## Product Change Notice (PCN)

**Subject:** Add tray and desiccant for RA Family/RA2 Series LQFP.

# Difference specification (LQFP Add tray & desiccant) 7x7mm,10x10mm

MCO-AB-23-0005  
PC-MCU-A012A/E

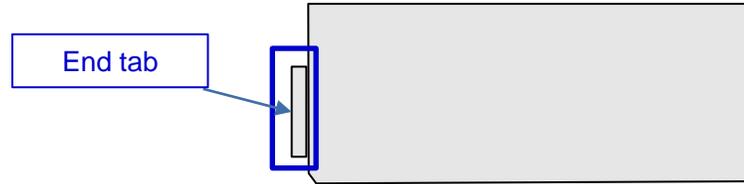
- ✓ Add a tray for the above package.
- ✓ The notation of the end tab is different for the current tray and additional tray.
  - However, the dimensions of the current tray and the additional tray are the same.

# Difference of tray-2

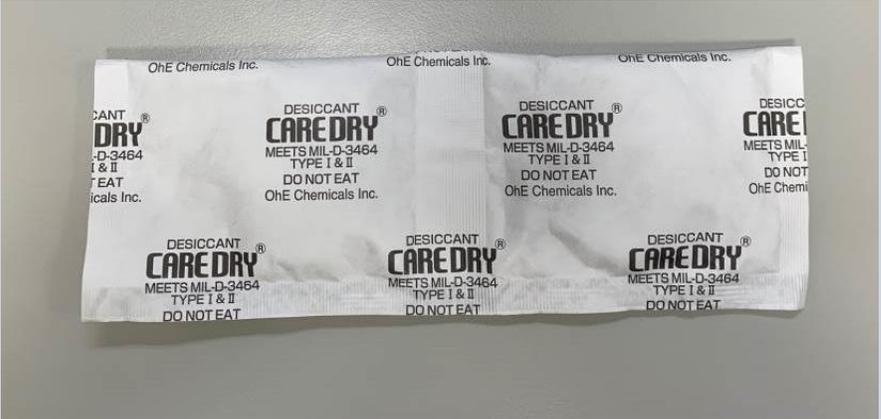
The notation of the end tab is different.
